Power Siting Board

November 17, 2010

Re: Hardin Wind Farm, Case Number 09-0479-EL-BGN

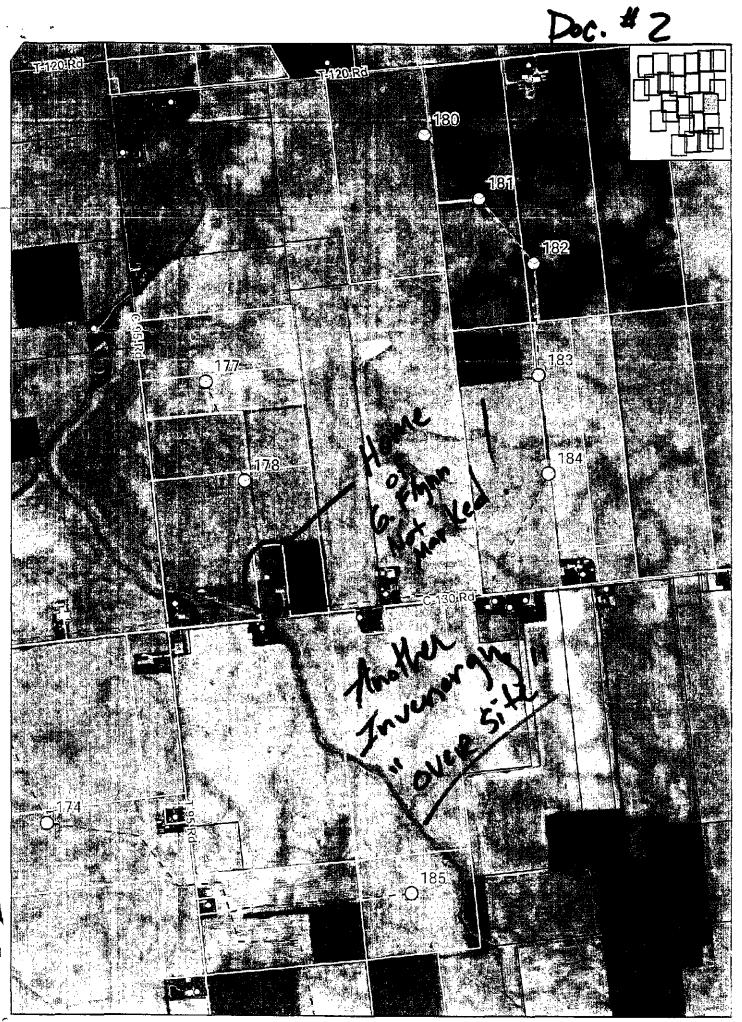
Thank you for taking the time to send me the map surrounding my family's home. I am glad that I brought this up because there has been some sort of over site on Invenergy's responsibilities as to the close proximity to my property. (Please see attached) I am sure this has been mistakenly over looked like all the other errors that the wind company has made. (For example, ignoring or "conveniently" over looking an entire co-op with 8900 members.) Someone is not doing their job.

I have not given them permission to use my property as part of their distance. My neighbor entered into a contract with Invenergy for a turbine, not my family. (Please see document #1)

With the existing proposed site, my boys playing in our back yard are subject to ice throw...on their own property!

- 1. What will be done to solve this problem and make it meet the Ohio Department of Health's distance from a non-consenting property owner?
- 2. There is also another property owner's house not even marked as a dwelling two houses to my west. (Please see document #2) Does his family not have rights either in Invenergy's eyes? I am sure this is just another mistake?

Thank you for bringing to our attention a few errors in the Hardin Wind Farm case. We regret that your property was erroneously identified as a participating parcel in the maps that were sent to you. Your property was listed as non-participating in the maps in Hardin Wind Energy LLC's application filed on September 18, 2009. An update to the property data submitted by the Applicant to the OPSB was used to create the maps that appear in the Staff Report. The updated data contained the error identifying your property as participating.

Despite the error, your property was treated as a non-participant for purposes of determining setbacks. The minimum setback to a non-participating property, as established in Ohio Revised Code 4906.20(B)(2), is 1.1 times the total height of the turbine. In this case, the Applicant proposed a maximum turbine height of 398 feet; therefore, the minimum statutory setback equates to 438 feet from the nearest non-participating property. The Applicant used a 1.5 multiplier for property setbacks, which equates to 597 feet. According to our records, the nearest edge of your property is approximately 790 feet from the nearest turbine (Turbine 184).

The minimum setback to the edge of the nearest habitable residence is established in the Ohio Revised Code as 750 feet from the tip of the turbine's nearest blade at ninety degrees. In this case, the Applicant proposed a maximum blade length of 135 feet; therefore, the minimum statutory setback equates to 885 feet from the nearest residence. The Applicant chose to apply a 1,000-foot setback from all residences. According to our records, the nearest edge of your home is approximately 1,070 feet from the nearest turbine.

It appears that the residence of G. Flinn, 8645 CR 130, was omitted from the Applicant's database of residences. According to our records, the nearest turbine is approximately 680 feet from the Flinn property and 1,130 feet from the Flinn residence, which exceed the minimum setbacks required by the Ohio Revised Code and the greater setbacks established by the Applicant. However, because the residence appears to have been omitted in the application, the impacts to this residence may not have been properly evaluated. We will be in contact with the Applicant to determine what studies need to be conducted again to include the Flinn residence, and ensure that this residence is included in all future studies. Any results would become part of the public record for this case. Thank you again for bringing this oversight to our attention.

In regards to ice throw, the turbine manufacturer recommends the use of an ice detector if people or objects are within 800 feet of the Applicant's proposed turbine model. The Applicant has stated that the turbines would have ice detection sensors that trigger automatic shutdown. The OPSB certificate requires that the Applicant adhere to these safety measures. In addition, the certificate requires the Applicant to train all workers on the potential hazards of ice conditions. In the event that the project is constructed, the Applicant would be required to remedy any unsafe icing conditions reported by property owners. The Applicant is required to establish a complaint resolution process through which all such concerns are adequately addressed.
